ND-17-1811
10 CFR 50.90
10 CFR 52.63

Southern Nuclear Operating Company
Vogtle Electric Generating Plant Units 3 and 4
Request for License Amendment and Exemption:
Consistency and Clarification Changes to Annex Building, Auxiliary Building
and Basemat ITAAC (LAR-17-040)

**Consistency and Clarification Changes to Annex Building, Auxiliary Building and
Basemat ITAAC**

Figure 3 - Example 8-inch Floor on Metal Decking

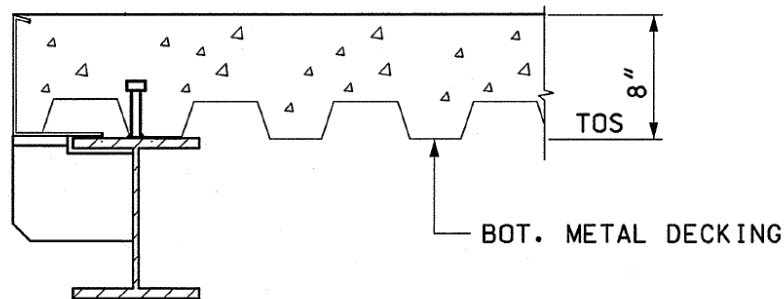
There are six floor sections in the Annex Building with ITAAC in COL Appendix C Table 3.3-1. The Annex Building concrete thicknesses in COL Appendix C Table 3.3-1 are consistent with the floor thicknesses as shown in UFSAR Figure 3.7.2-19 and include the depth of the metal decking as illustrated in Figure 3. However, by convention, the thickness to be indicated in COL Appendix C Table 3.3-1 is the concrete thickness, which for other buildings does not include the depth of the metal decking.

A change is proposed for the Annex Building concrete thicknesses in COL Appendix C Table 3.3-1 to add a note stating the concrete thickness for each floor reflects the thickness of the floor including the depth of the metal decking, where applicable. Table 1 presents a description of each Annex Building floor with ITAAC in COL Appendix C Table 3.3-1. Where the floor is supported on metal decking, the requisite sections making up the concrete thickness are presented.

- Three new notes associated with Table 3.3-1 are added, as described below:
 - Note 12 is added to describe that the concrete thickness acceptance criterion for each of the Auxiliary Building floors, where applicable, is the total floor thickness, including the metal decking.
